# Fossgate Redesign

## September 2018 Consultation

Following the public consultation on proposals for a redesign of the street layout on Fossgate, York Cycle Campaign have consulted our membership via an online survey on matters within the design that might have an effect on cycling in the area.

A proposed concept of how an alternative true pedestrian/cycle street could work, with widened footpaths (green), a distinct cycle lane (blue) and bi-directional vehicle access to the south (red).

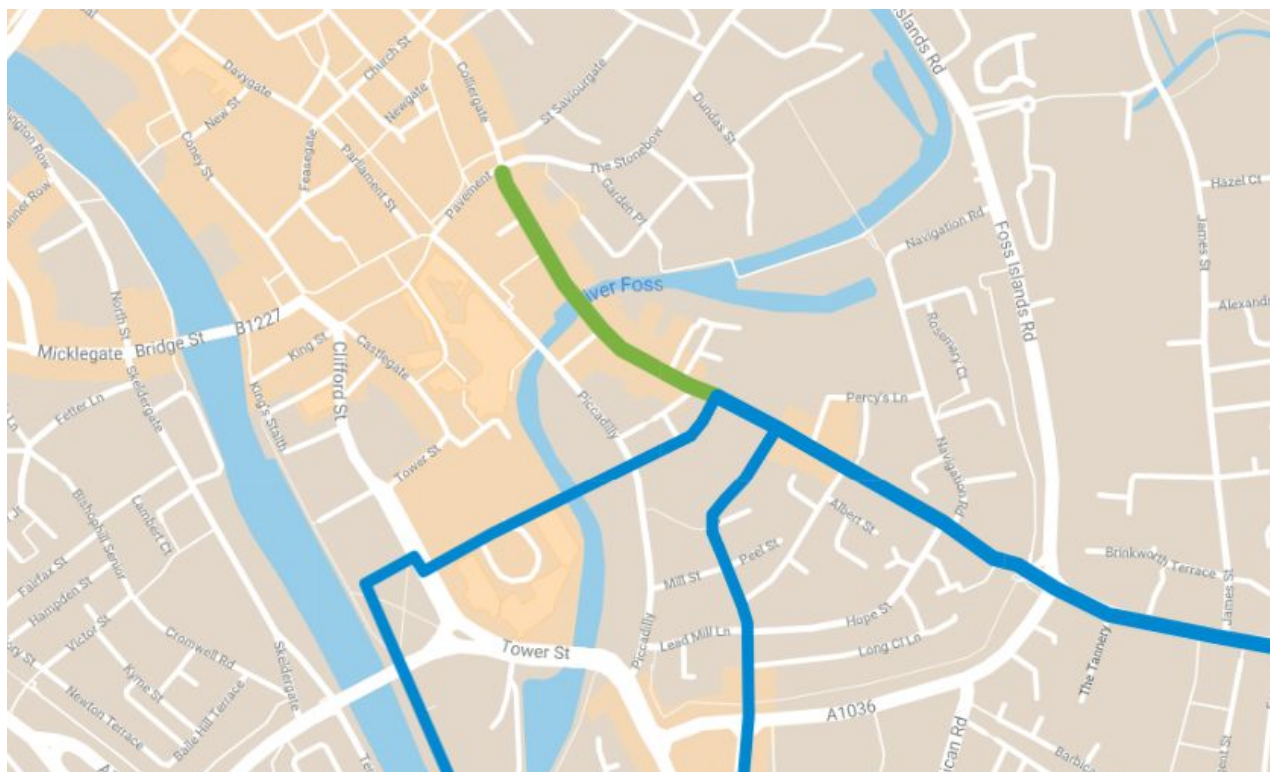
Another alternative suggested within the Campaign, and widely supported by members in the survey (90%) would be to limit motor vehicle access only to the lower end of Fossgate in a two way direction, as far as Franklin's Yard (Ambiente/The Hairy Fig), allowing only pedestrians & cyclists the rest of the street. This would still allow access to the parking provided for residents & not restrict those with blue badges, whilst providing a much safer pedestrian & cycling street for the rest of Fossgate at its busiest end by removing
